OFFICIAL MINUTES
SUMMERSET PLANNING AND ZONING COMMISSION
REGULAR MEETING
MONDAY, OCTOBER 7th, 2024 @ 6:00 P.M.

Norman Ranch Design Exception Request (11-01-24)

Review Comments (11/05/24)

Norman Ranch Utility Report (11-01-24)

FREEDOM TRAIL TURNAROUND
 S-BUS TURNAROUND
 MOVEMENT EXHIBIT
 RAPID CITY, SOUTH DAKOTA
 OCTOBER 30, 2024

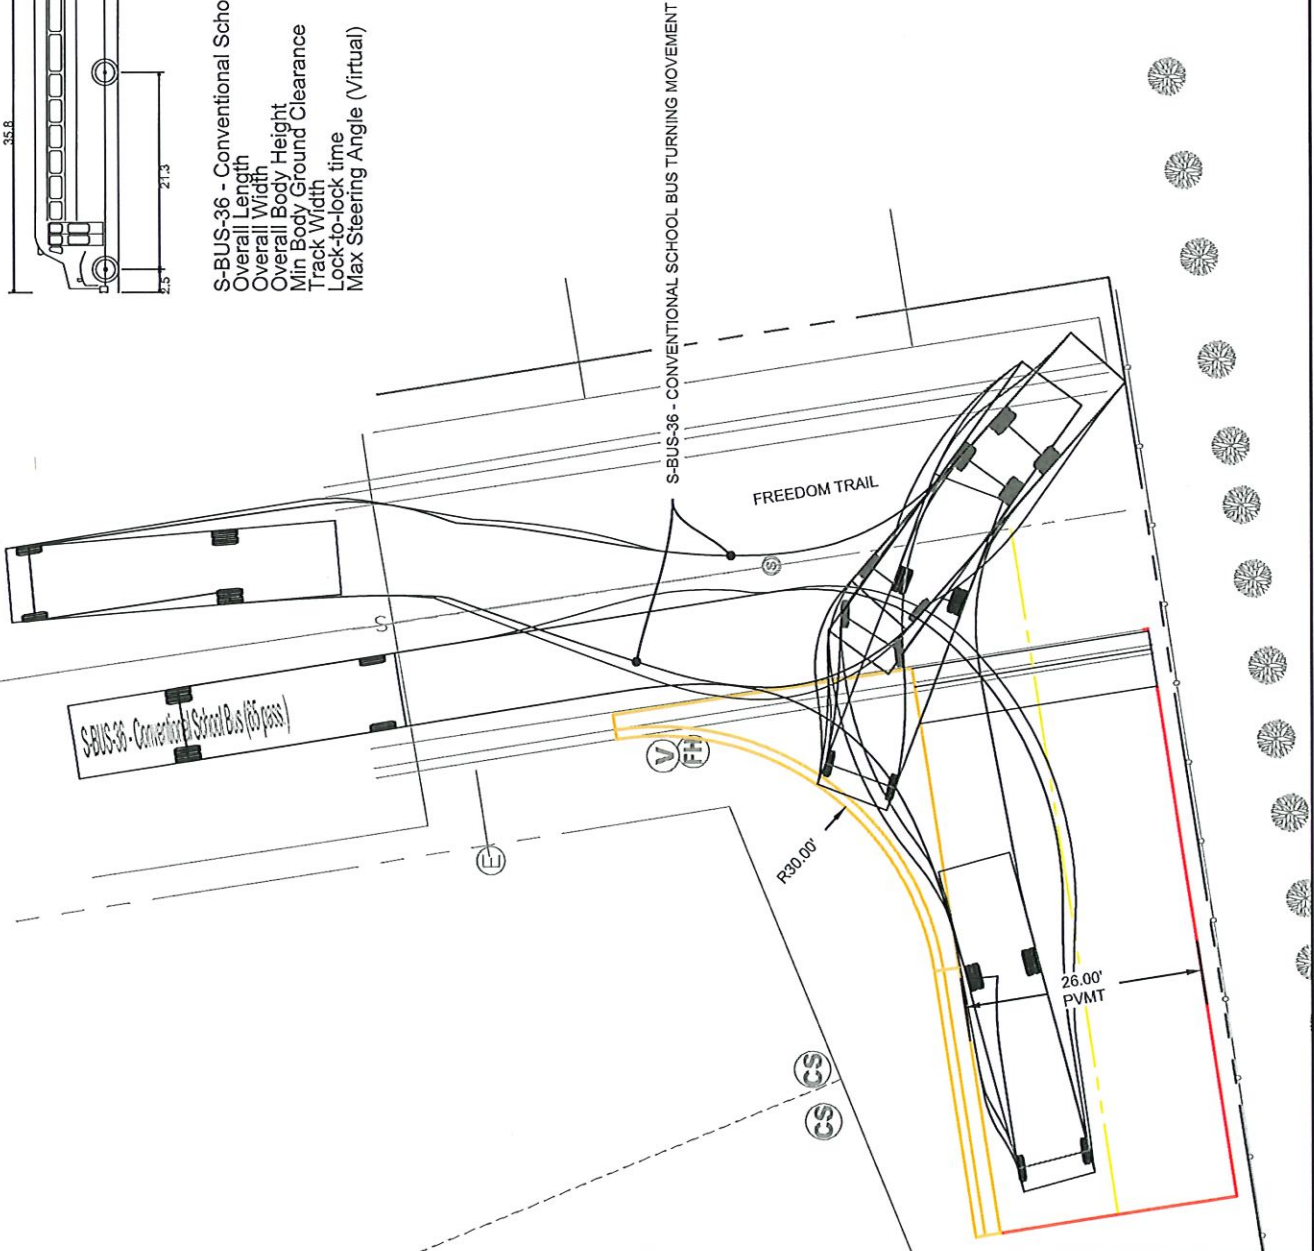
Comments **Need to show Highway 79 ROW width and Outlot E on west side.**

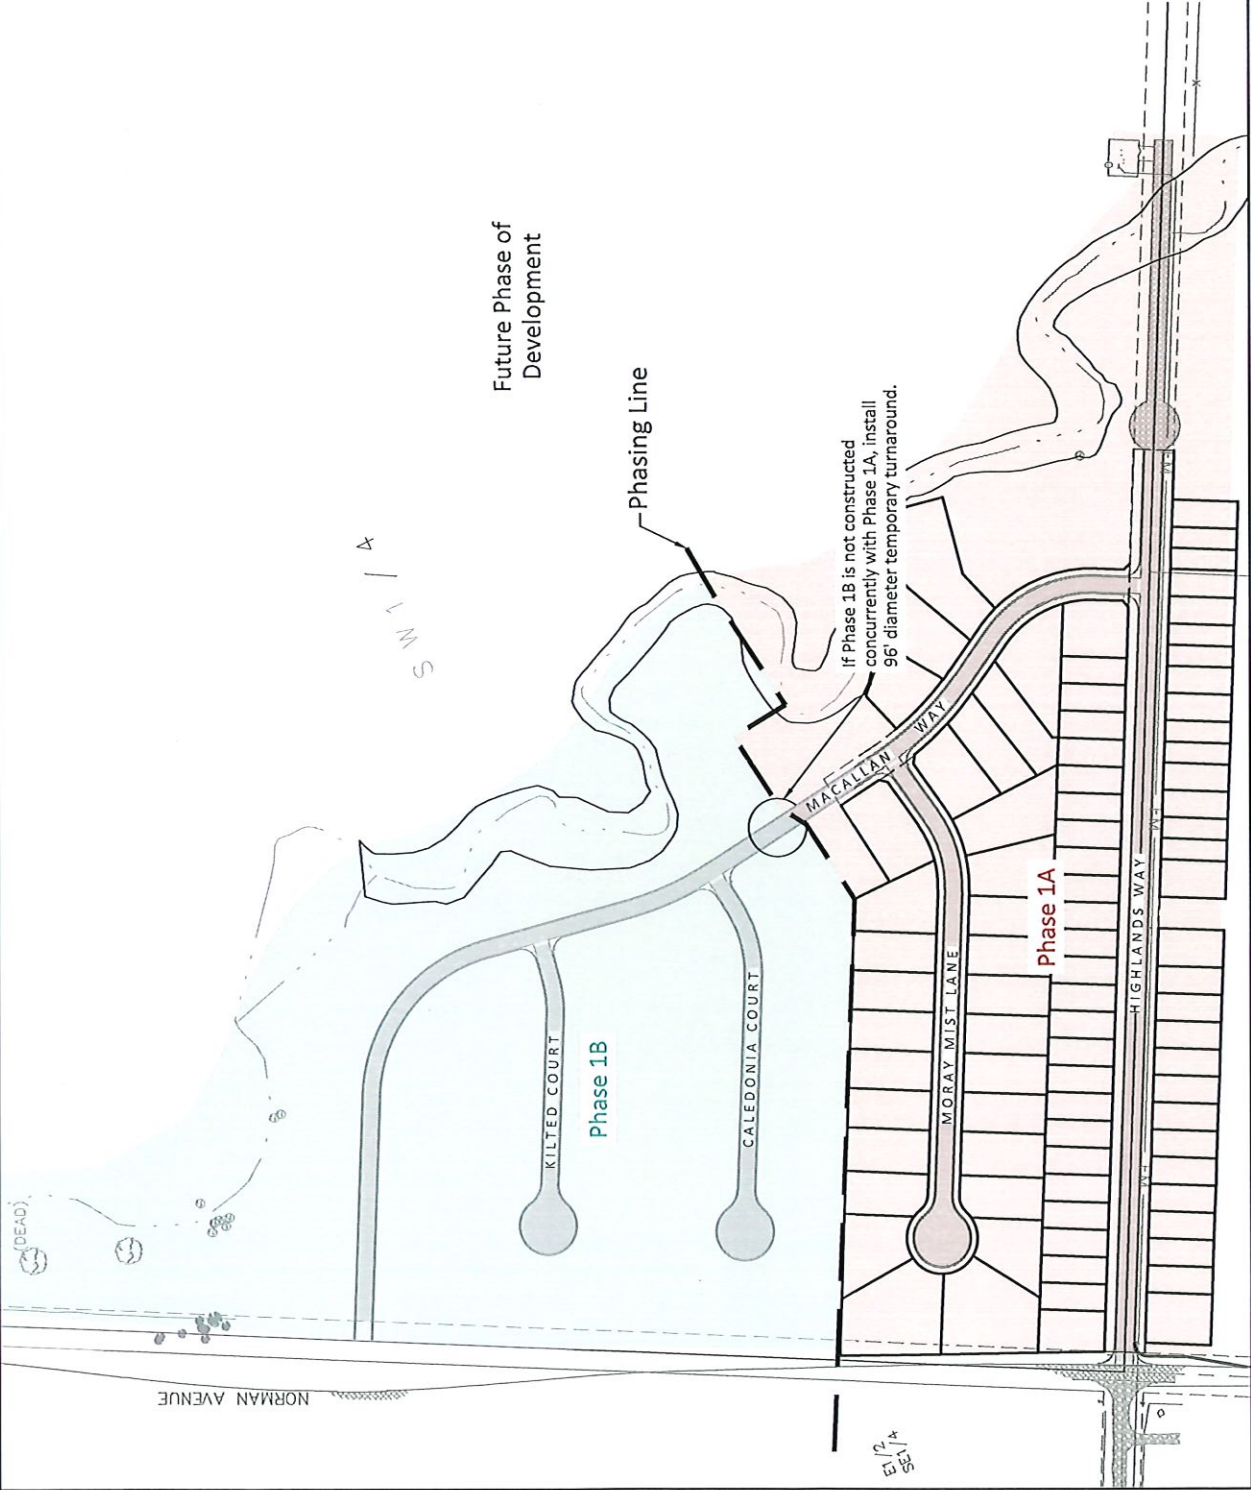
- a. An 8" FM would experience a 0.5 ft/s velocity until the pumps are replaced. It is not clear when pump replacement is proposed.
 - b. **Norman Ranch Response: Pumps would be ordered spring of 2025 with City review of shop drawings. Ideally – the Summerset Lift Station forcemain air release valves would be replaced prior to this time and a new pump test conducted. In which case upgraded pumps would be ordered with the initial installation. Otherwise new pumps would be ordered at phase 2.**

- b. **Norman Ranch Response: Yes, and ideally sooner per above.**
6. Utility Report states “The table below illustrated the theoretical capacity of the Summerset lift station and the proposed flows for each phase of Norman Ranch.”

- a. See above response related to theoretical capacity of the Summerset lift station.
7. Utility Report states “The 8" FM would meet the 2 ft/sec when approximately 50% of Phase 2 would be constructed.”

- a. Are Norman Ranch LS improvements proposed during phase 2? If so, the timing does not match the table presented in the revised Utility Report where Norman Ranch LS improvements are not proposed until phase

- b. **Norman Ranch Response: Agreed. The essence of the request is that a 4" or 6" main limit the potential for growth downstream without the installation of a second force main. By installing an 8" (or 10" as originally proposed) line initially it allows us to budget for Summerset Lift Station Improvements and Norman ranch Pump Upgrades with Phase 2. Our ability to do all three (upgrade summerset lift station, Norman ranch pumps and force main) is not possible within current lot value/improvements conditions.**

- b. **Norman Ranch Response: Yes, Improvements to the City of Summerset and Norman Ranch Lift Station are planned in Phase 2, to be designed during those phases.**

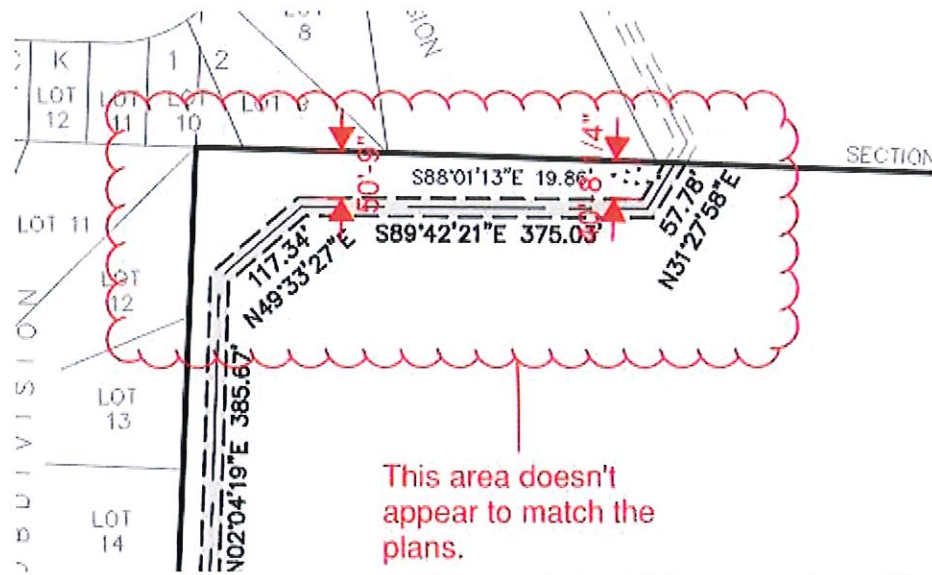
10. A meeting took place where HDR suggested addressing a list of items associated with a lift station design. Items that were requested to be addressed but are either absent or lacking detail:
 - a. Odor control
 - b. Data for all proposed valves (check, isolation, air and vacuum)
 - c. Inclusion of a flow meter
 - d. Noise control
 - e. Power plan
 - f. Instrumentation and Controls (pump control logic, proposed instruments, plc inputs, alarms/communication)
 - g. Design FM to convey a pig (pig launch added at lift station but its unclear if valves are full port).
 - h. The proposed air release valve is for water and not appropriate for wastewater service. The valve is air release only, combination valves are anticipated to be required is some locations.

11. New aerial on Sheets 5.11-5.20, appears to be covering property line and topographic survey linework.
12. Missing a section of forcemain in profile view on Sheet 5.15.
13. Alignment of sewer in on the north side of Tract C of Lot 3 appears closer to the lot line than what is shown in the easement exhibit, confirm which alignment is correct and update documents, see below

This is from Exhibit A for Tract C of Lot 3 of NE1/4 of SW1/4 of Section 31 (dated 6/5/2024), if there is a newer version that is correct, please submit.

15. Electrical plans are not included.
 - a. Will 3-phase power be available at the site?
 - b. Type and location of pump control panel enclosure?
 - c. Heated and air conditioned?

17. A building has been added to the recent plan revisions. Building details and specification have not been provided.
 - a. An "Odor Control Dosing System" is called out on the lift station site drawing. No other information has been provided on the system. There does not appear to be access to the tank for exchange/refill. No pumps, controls, or other odor control system components are included.

18. Verify jib location and capacity.
 - a. Specifications for jib crane have not been provided.
 - b. Will this be able to lift the larger future pumps (Phase 2/3)?

19. Pig Launch Chamber opening is adjacent to the vault wall. Verify adequate space is provided for pig insertion.

Norman Ranch Phase 1A Plans (9-25-24)

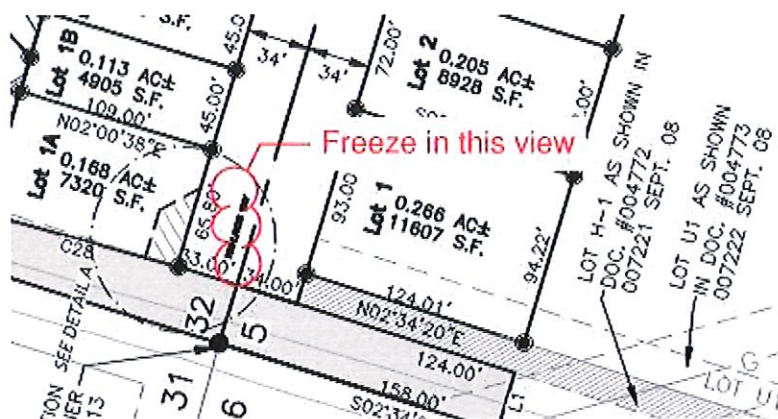
20. Will need USACE jurisdiction determination/approval prior to 15" storm culvert and riprap from the pond, the 72" culverts and riprap and gravel road installation work in existing drainage.

26. Approval from SDDANR for Norman Ranch Sanitary Force Main and Water Main plans and specifications: Approved with conditions.
27. SDDANR Stormwater Discharge for Norman Ranch Subdivision: Received approved permit.
